BID #709 – Ventura College STEM Program Building Improvements

ADDENDUM 001, dated 05/15/2025

DRAWING changes and clarifications noted as Addendum 01 and dated 05/15/2025:

DEMOLITION PLAN

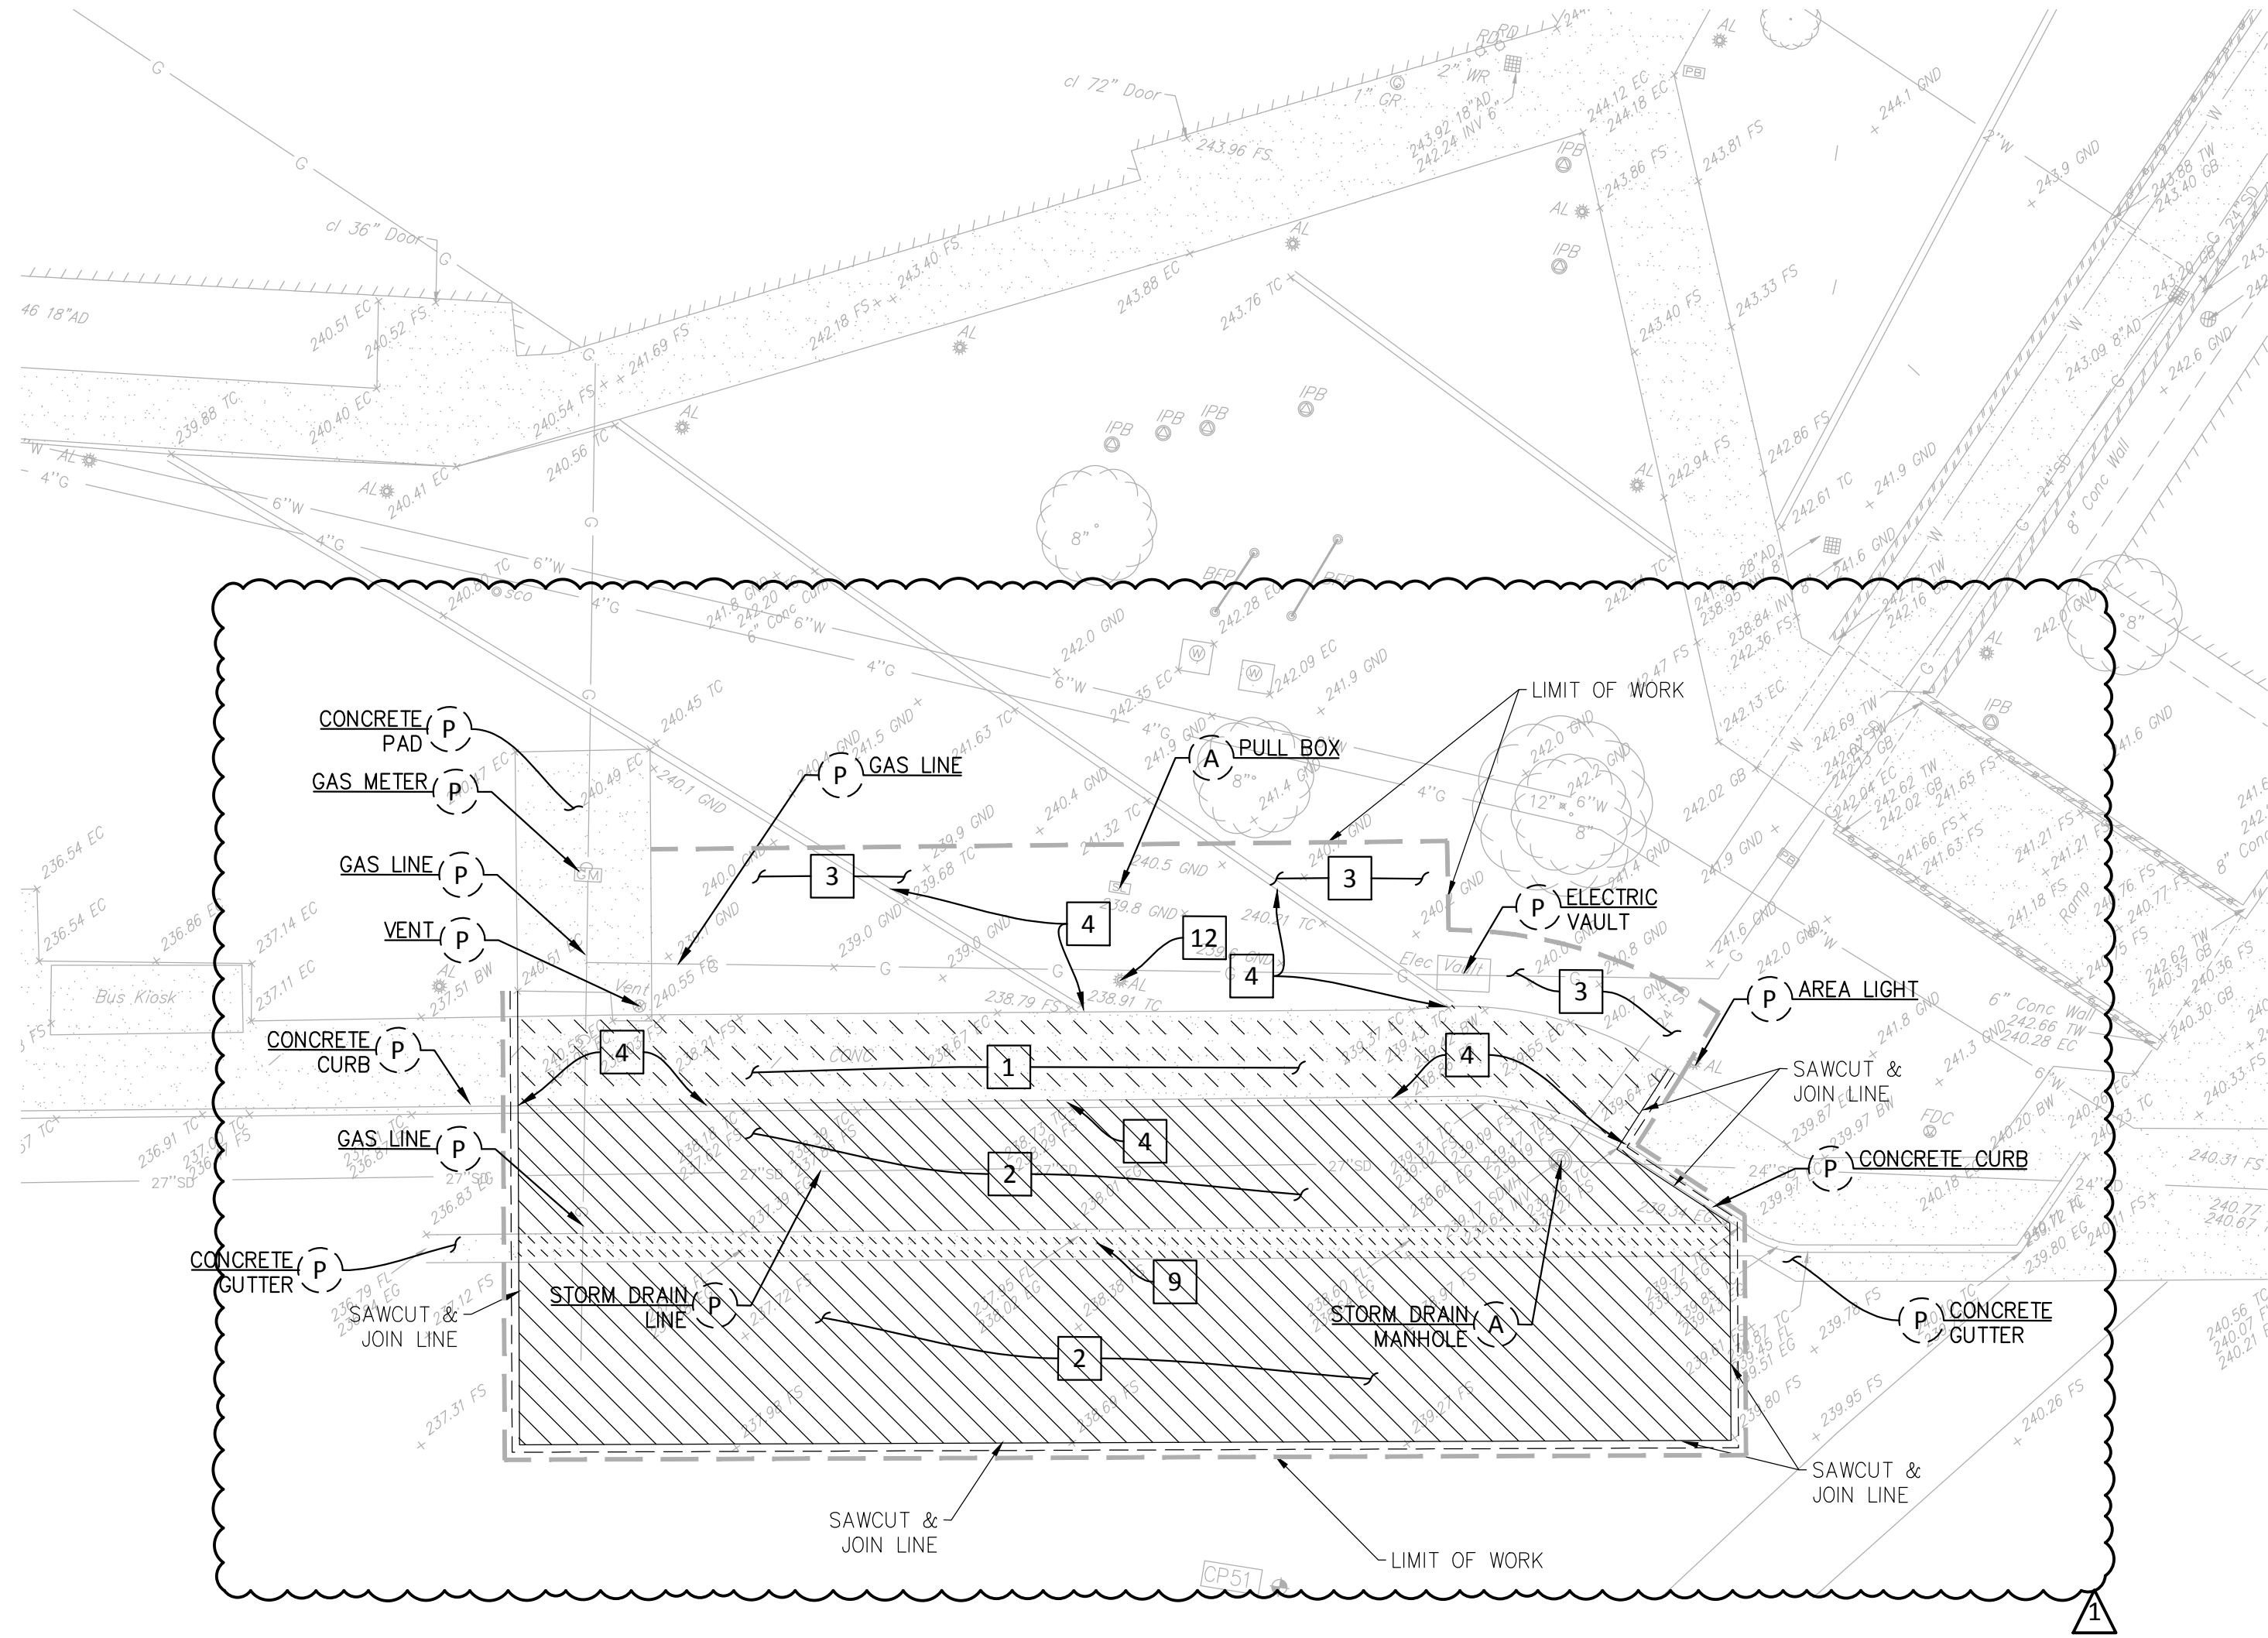
C2.0 – ADDED DEMOLITION FOR SEWER TRENCHING, ADDED EXISTING SEWER LINE WITH PROTECT IN PLACE NOTE, DEMOLITION NOTES 8, 9 AND 12

SHEET NUMBER: C2.1

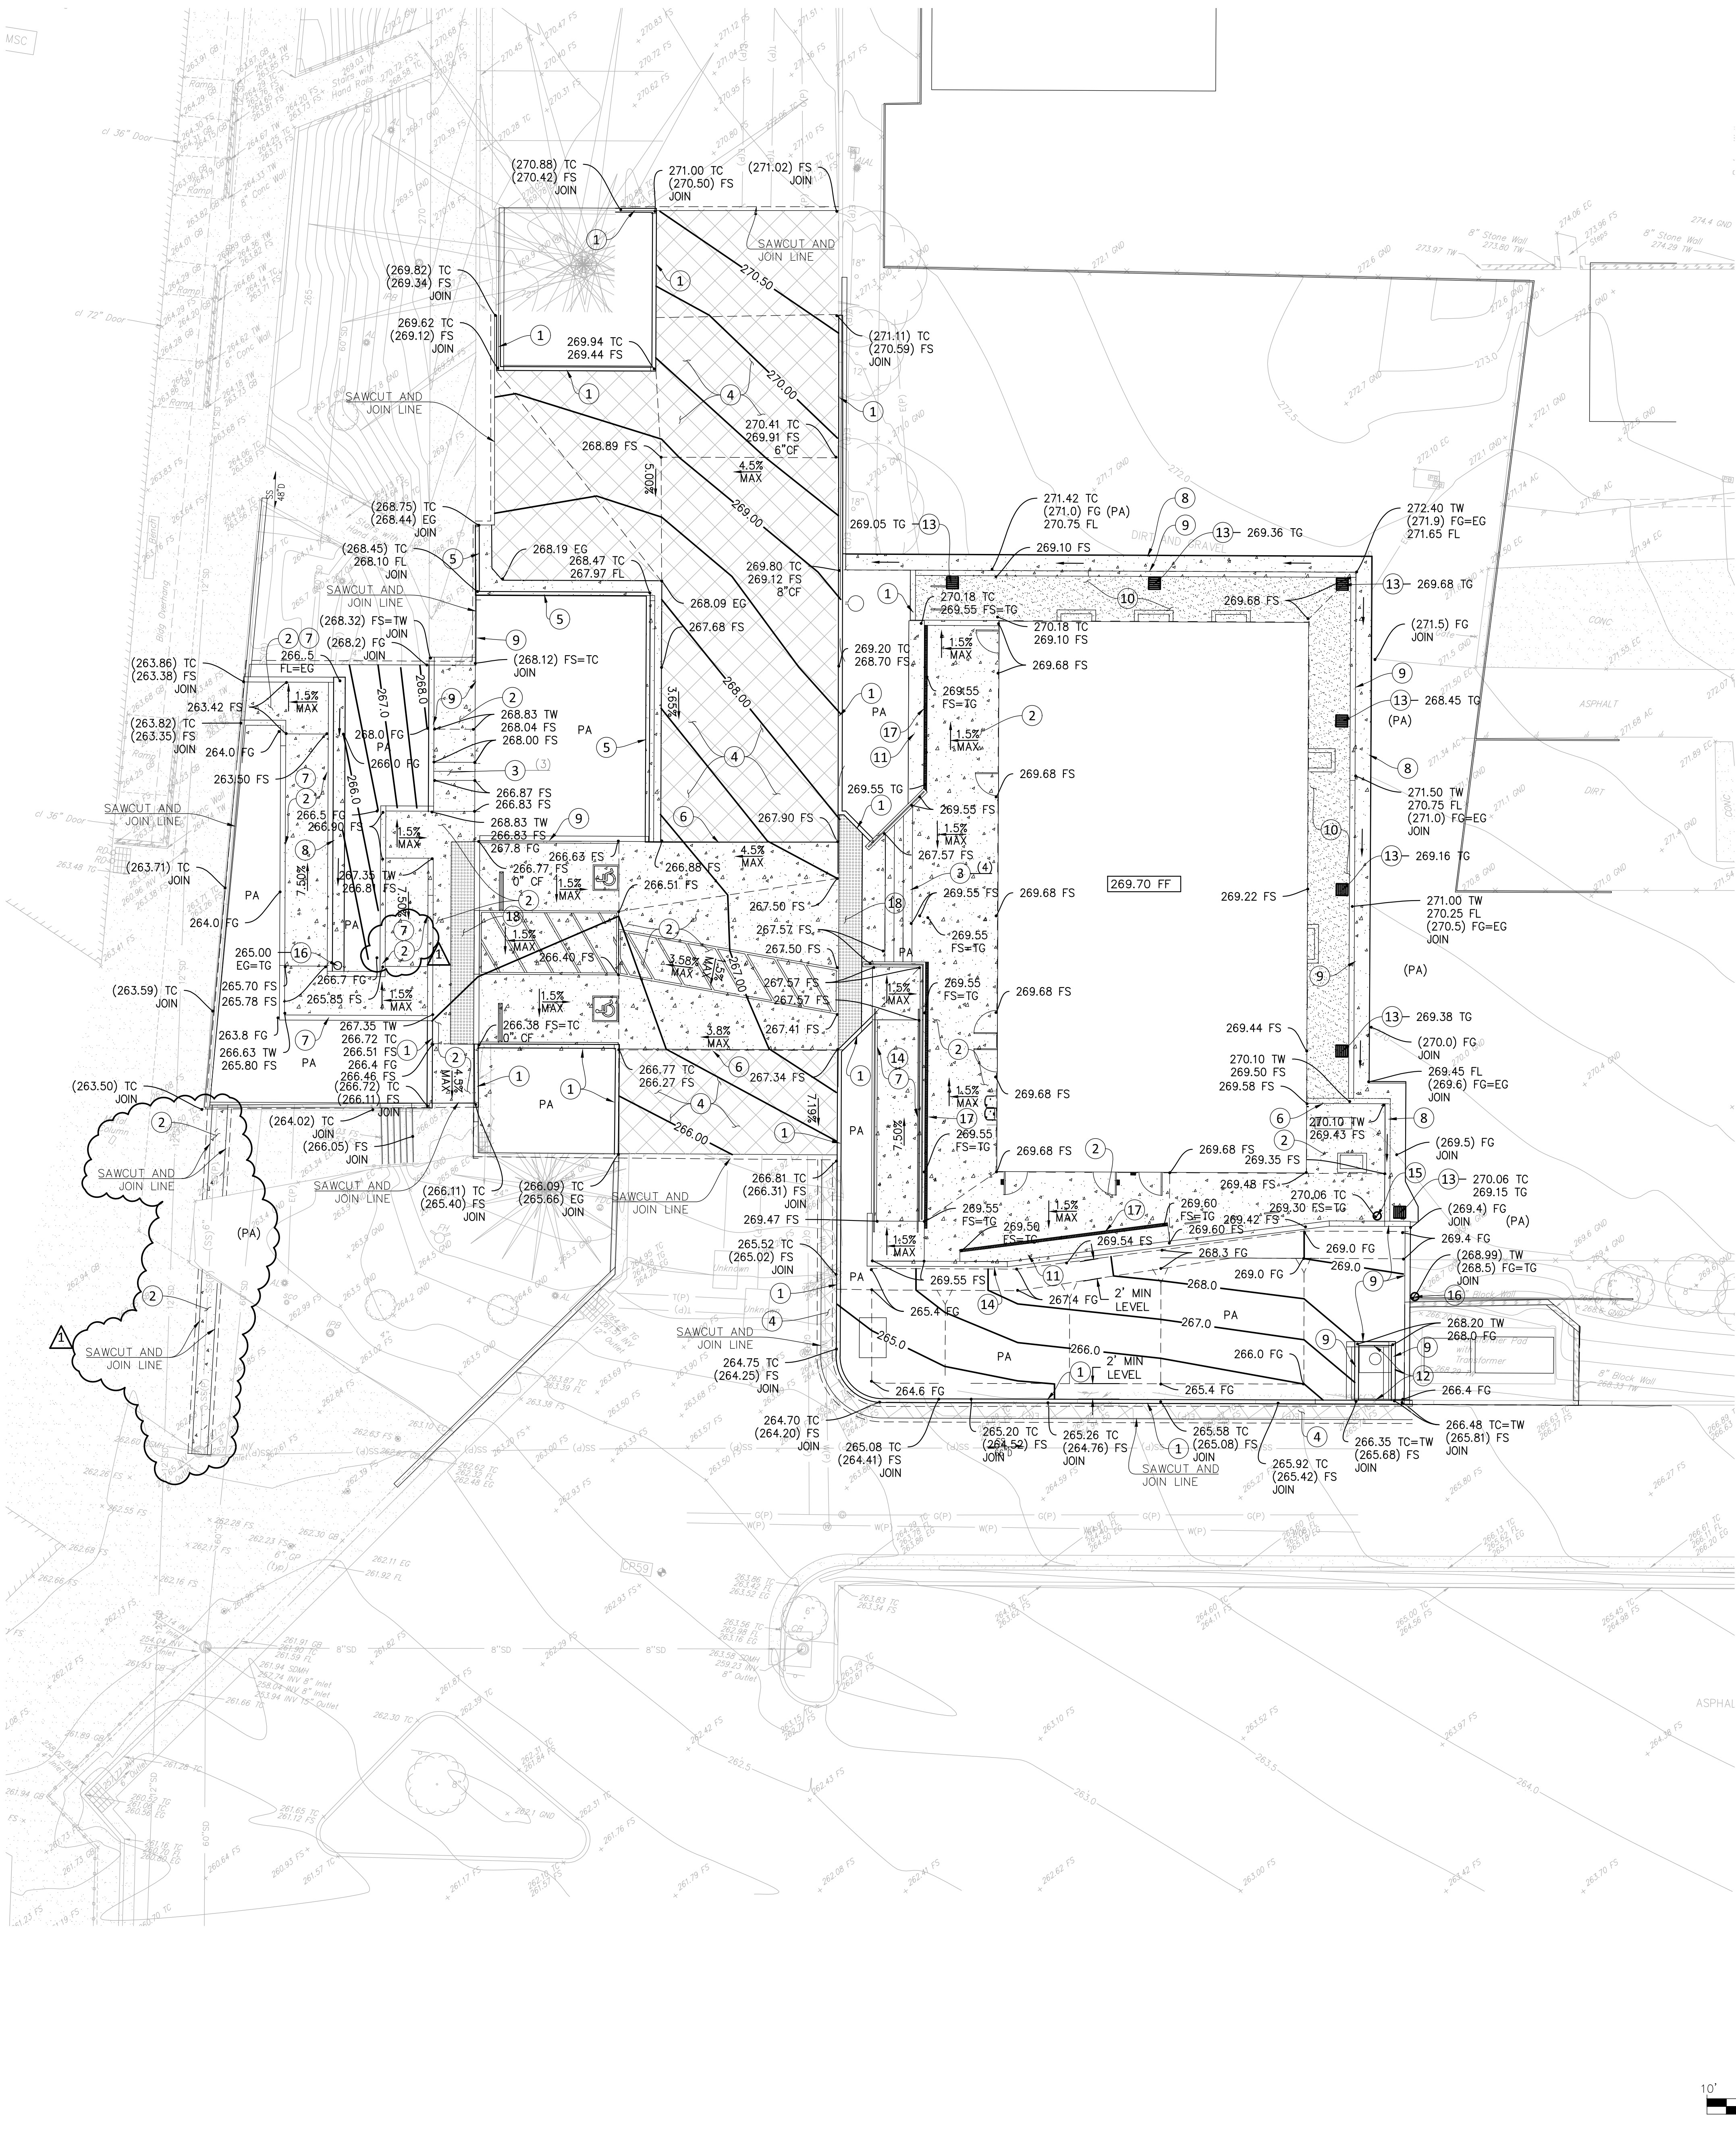
C2.1 – DEMOLITION PLAN FOR DROP-OFF AREA

SHEET NUMBER: C3.1

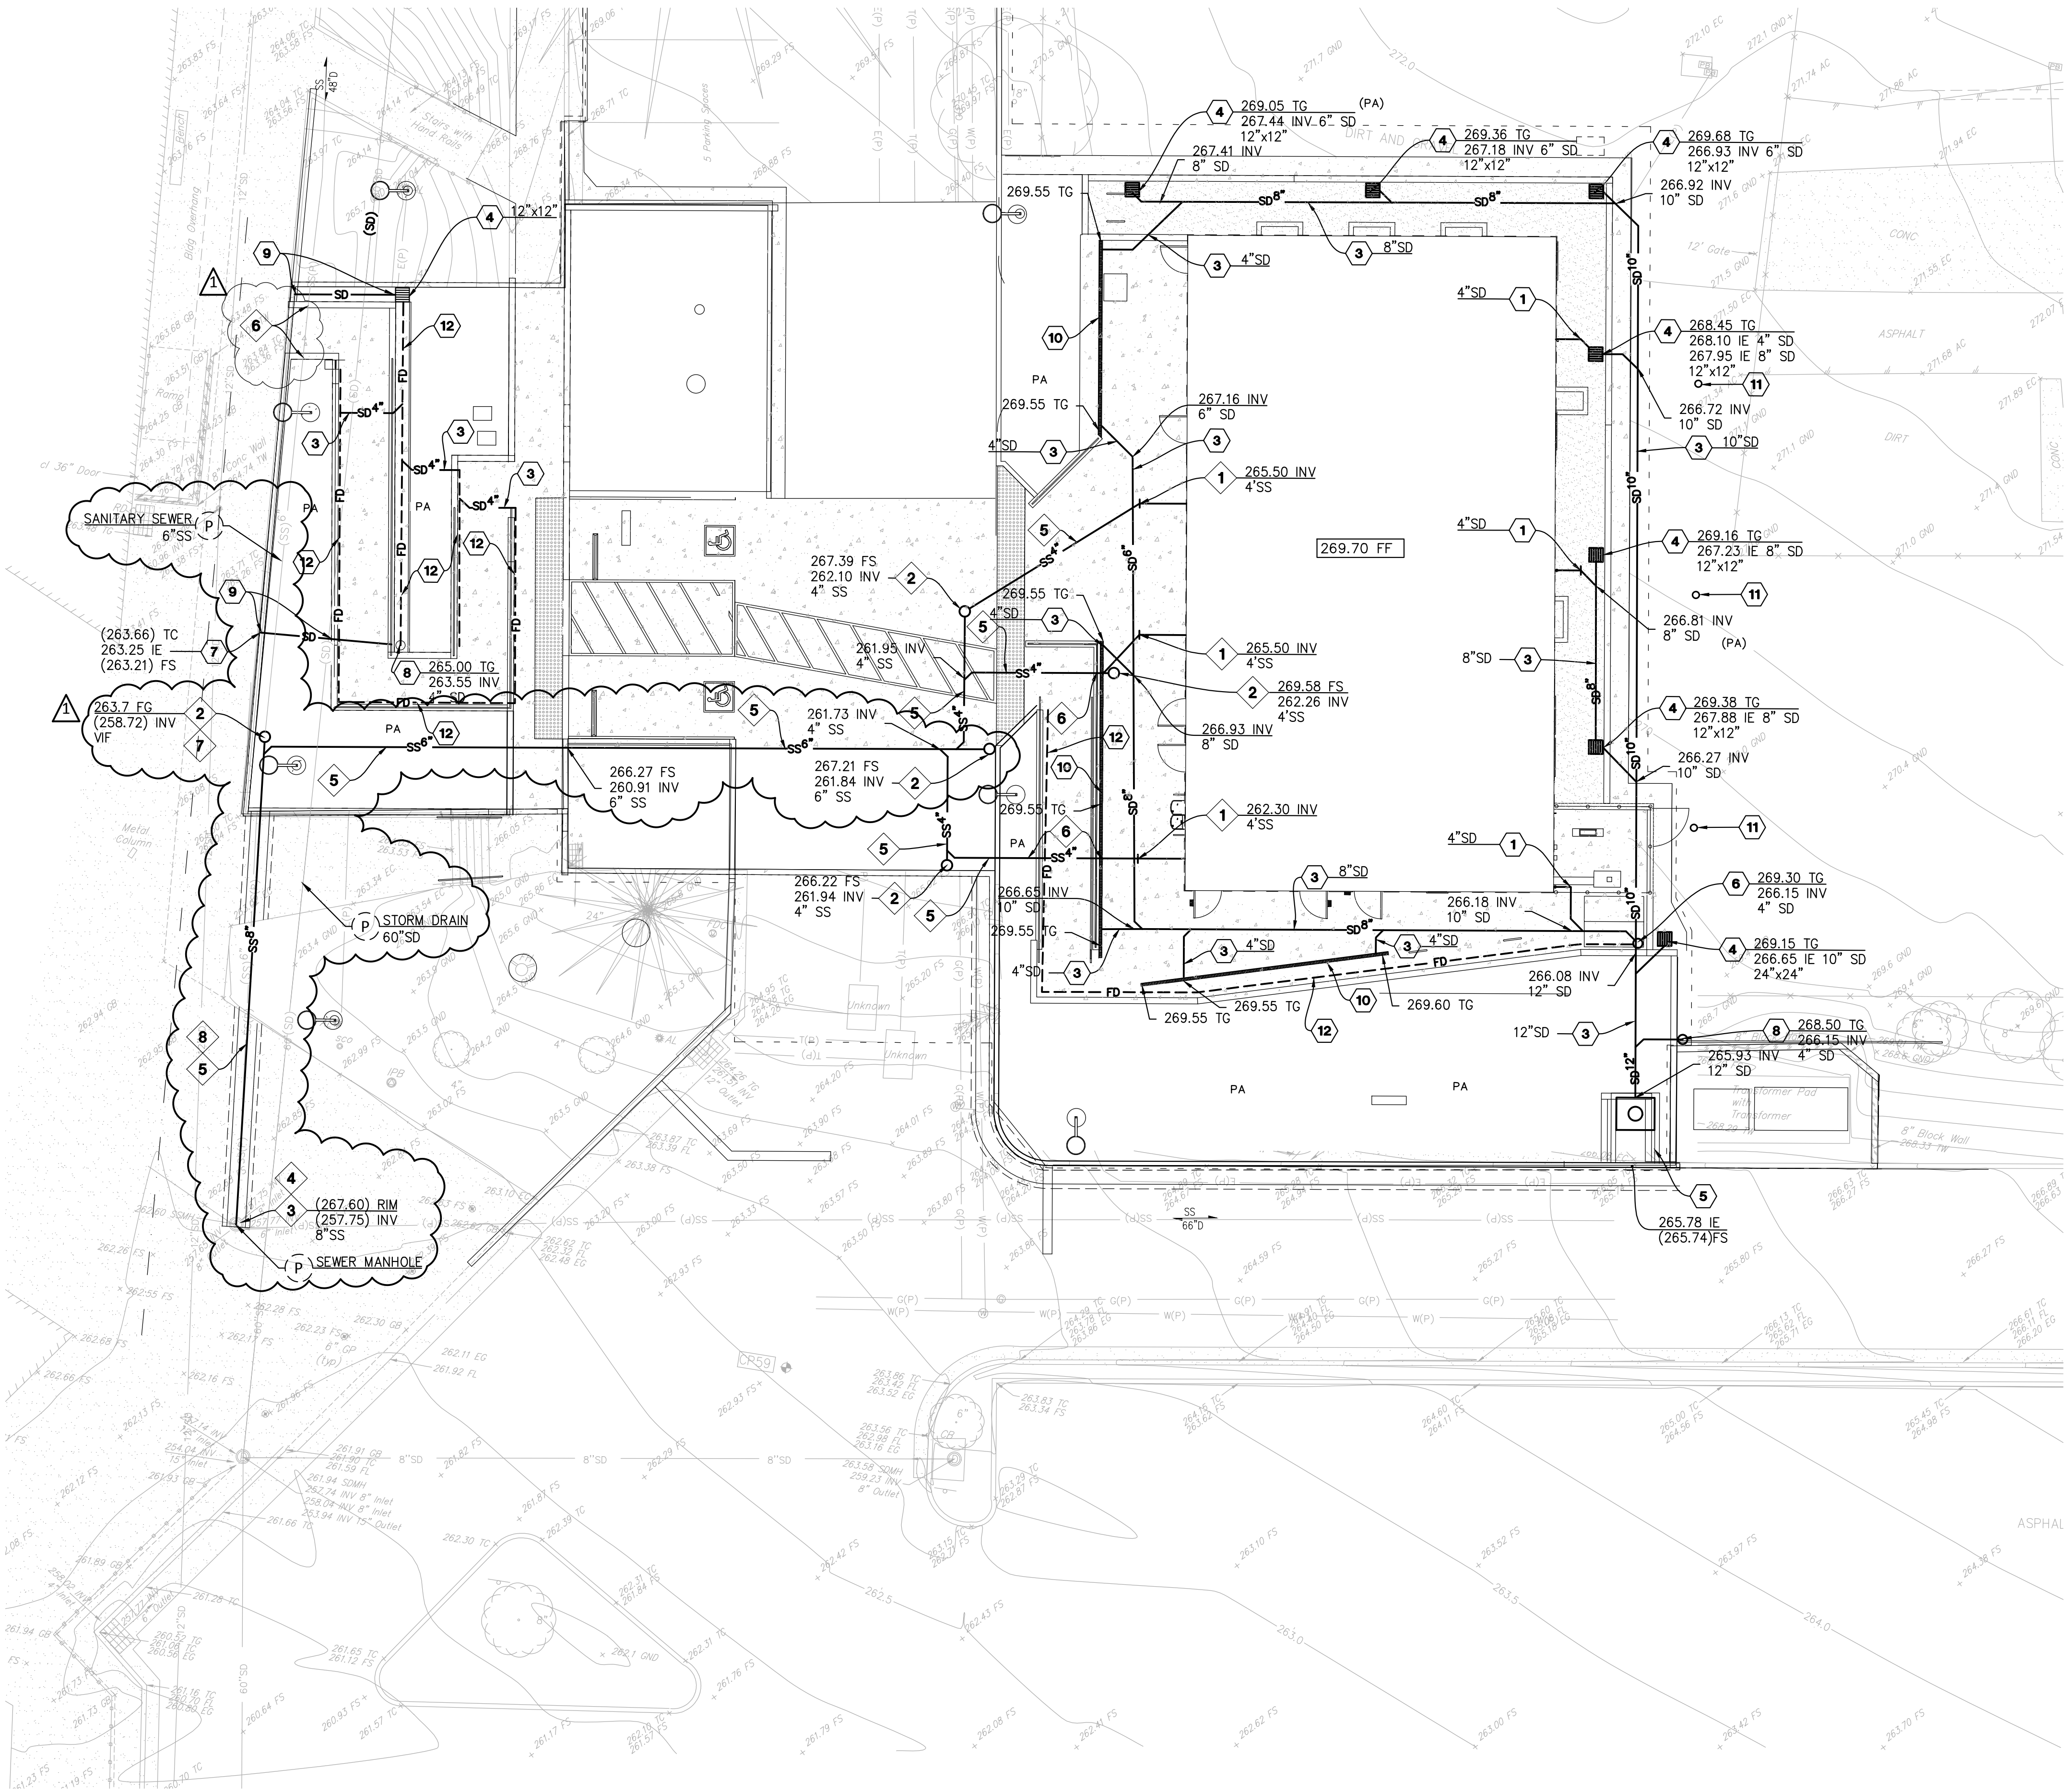
C3.1 – GRADING PLAN FOR DROP-OFF AREA
